DRAINAGE INFORMATION SHEET

PROJECT TITLE: PARKWAY UNIT TWO ZONE ATLAS/DRNG. FILE#: H-9 / P1A1
 LEGAL DESCRIPTION: UNPLATTED LANDS IN SECTIONS 9 & 16, T 10N, R 2 E
 CITY ADDRESS: WEST SIDE UNSER BETWEEN I-40 AND LADERA DRIVE
 ENGINEERING FIRM: COMMUNITY SCIENCES CORPORATION CONTACT: DOUG HUGHES
 ADDRESS: PO BOX 1328, CORRALES, NM 87048 PHONE: 897-0000
 OWNER: SIVAGE THOMAS HOMES, INC. CONTACT: LARRY COLLINS
 ADDRESS: 5141 MASTHEAD NE, ALB., NM 87109 PHONE: 821-3511
 ARCHITECT: N/A CONTACT: _____
 ADDRESS: _____ PHONE: _____
 SURVEYOR: COMMUNITY SCIENCES CORPORATION CONTACT: CLIFF A. SPIROCK
 ADDRESS: PO BOX 1328, CORRALES, NM 87048 PHONE: 897-0000
 CONTRACTOR: N/A CONTACT: _____
 ADDRESS: _____ PHONE: _____

RE: GRADING AND DRAINAGE PLAN FOR PARKWAY UNIT TWO, (H9-D1A1)
ENGINEER'S STAMP DATED MARCH 3, 1993

DRAINAGE MANAGEMENT PLAN

GRADING & EROSION CONTROL PLAN

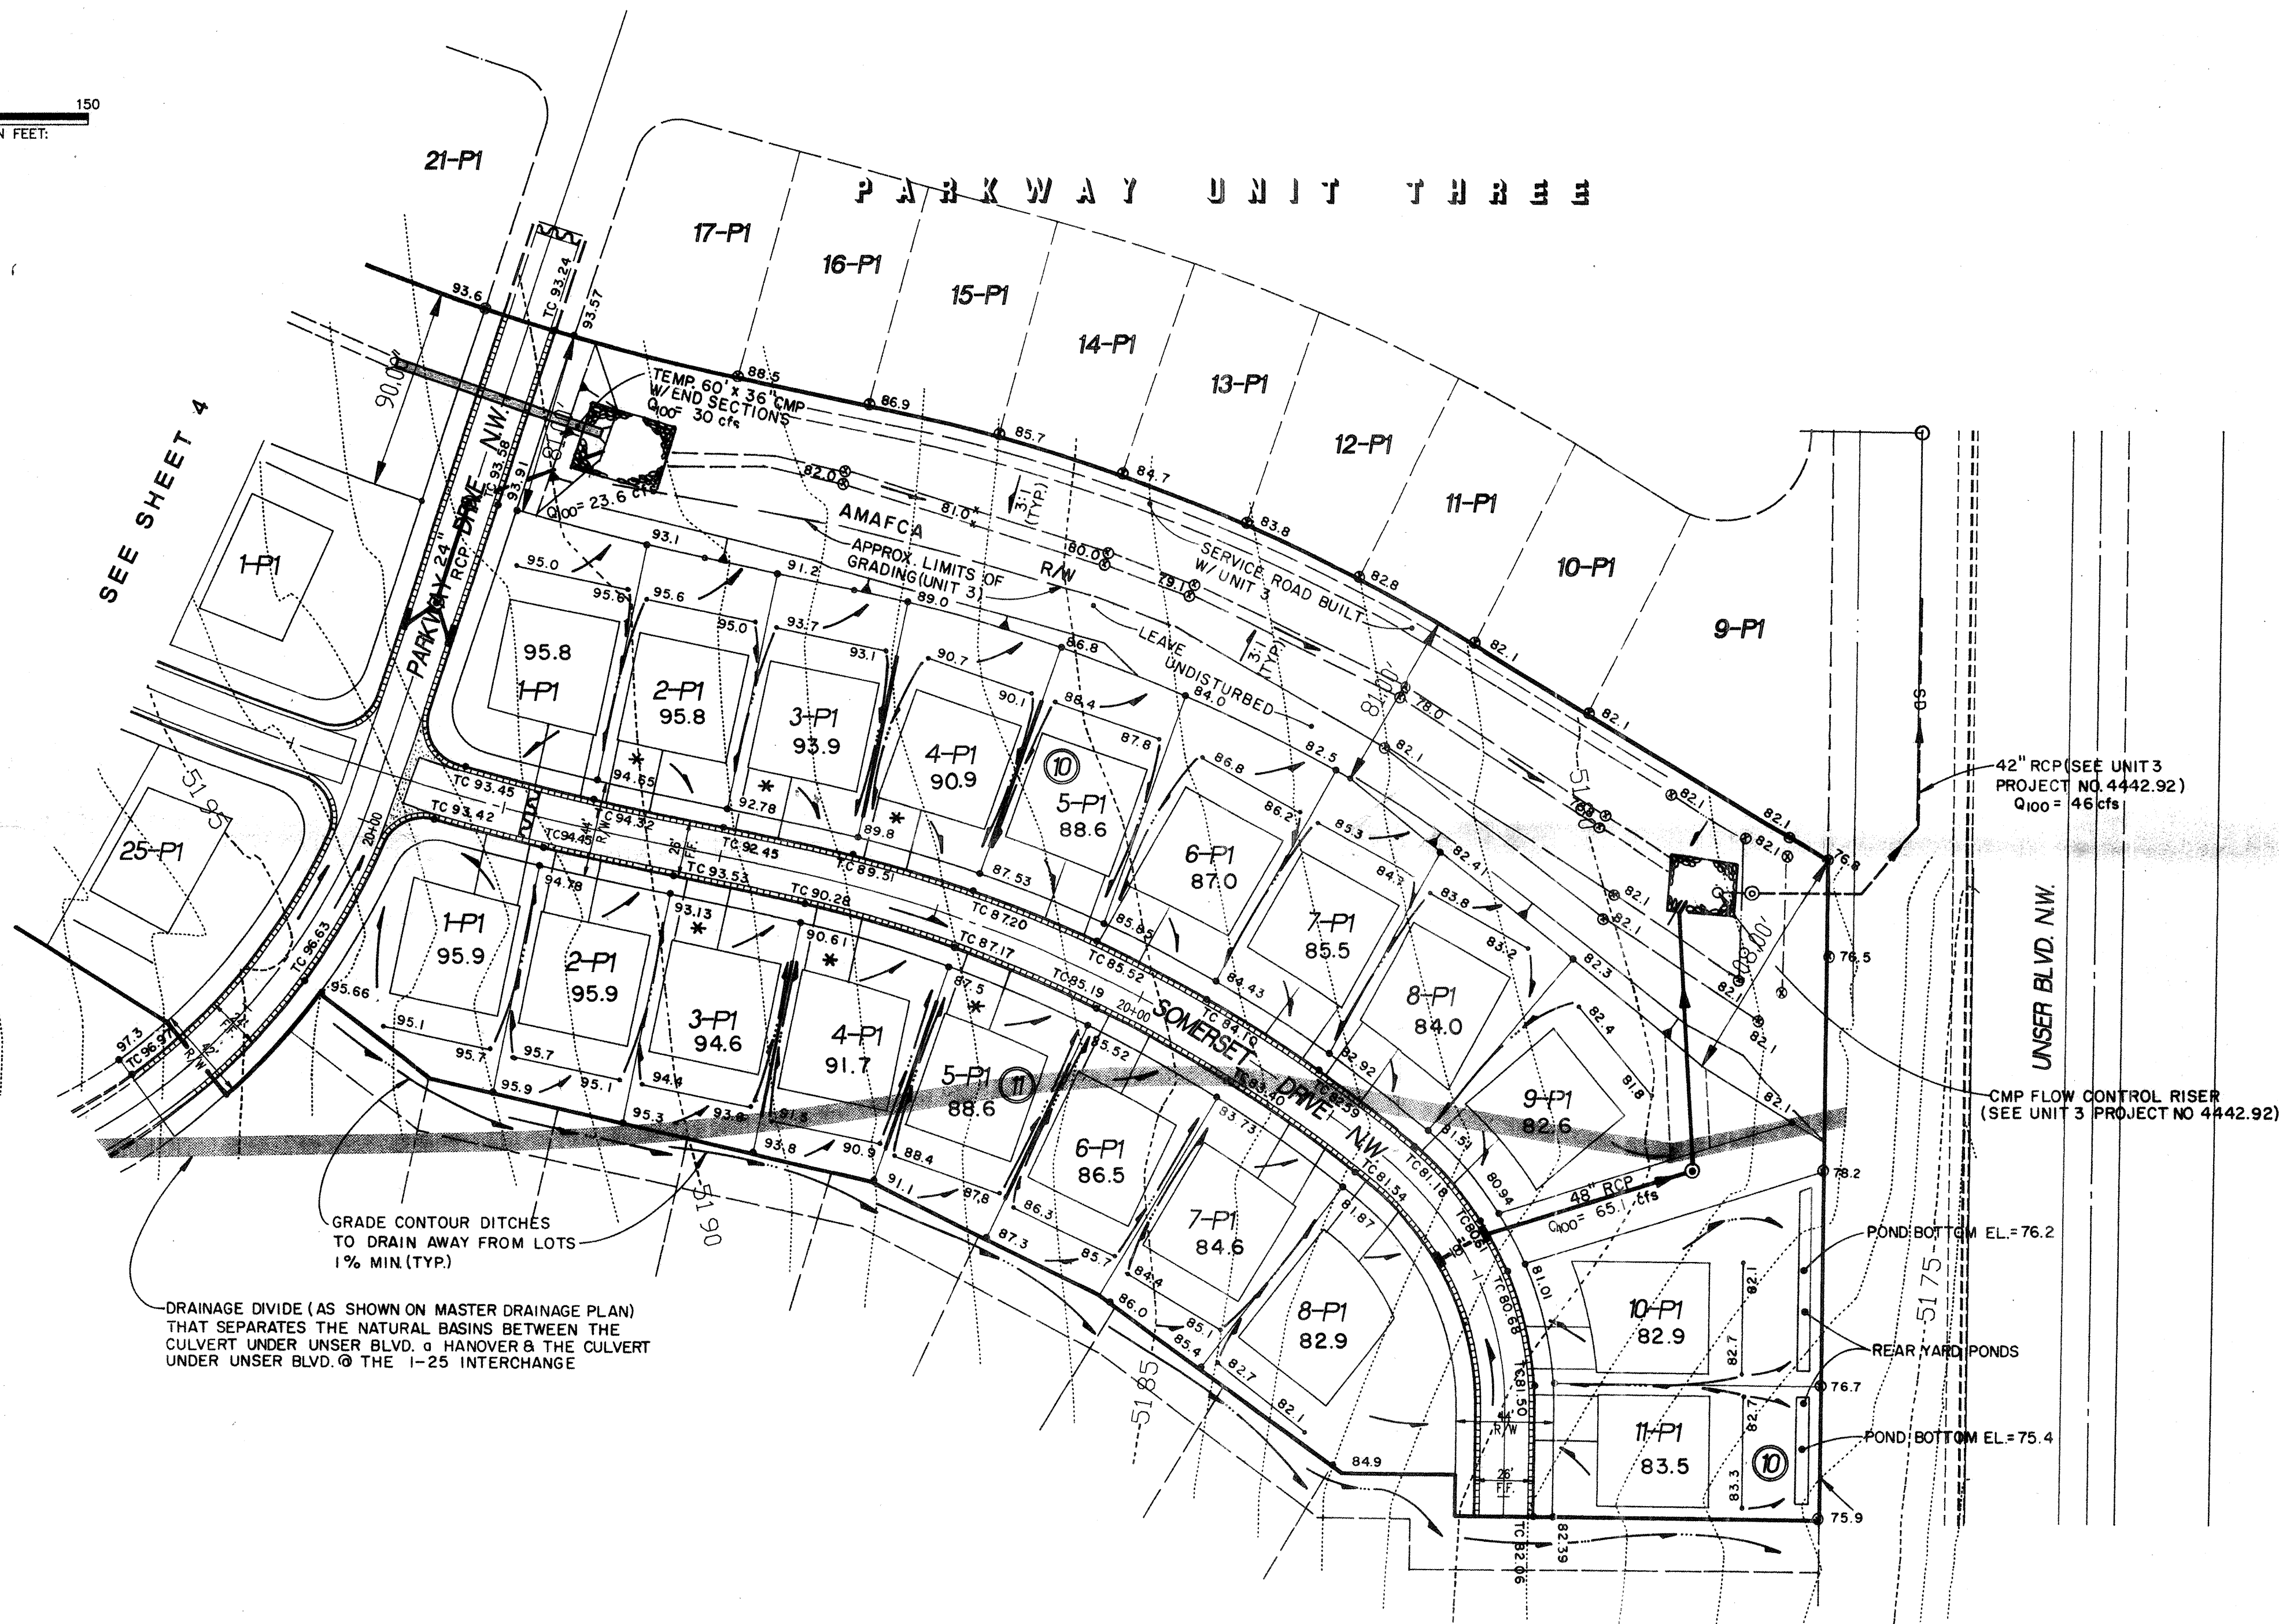
Please consider the following supplemental calculation and the recommendation for limited use of standard C&G as indicated at the bottom of sheet 4.

Just to be sure, I suggest adding standard C&G at the East curb return and 50' at the bottom of Brookhaven on the East side.
